City of Detroit Inter-Departmental Communication

Petition #428

Request to Convert to Easement The East/West And North/South Alleys In The

Block Bound By Fullerton, Lasalle, Montville, And 14th Ave.,

CIT	Y OF DETROIT	
CITY EN	GINEERING DEPARTMENT	
	SURVEY BUREAU	
JOB NO.	01-01	
DRWG. NO.	X 428

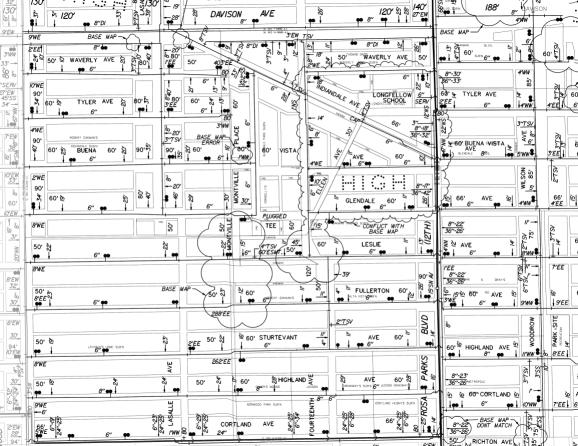
Our records indicate that there a sewer in the alley. DWSD has no objections to the conversion to easement provided that the attached provisions for conversion to easement are followed.
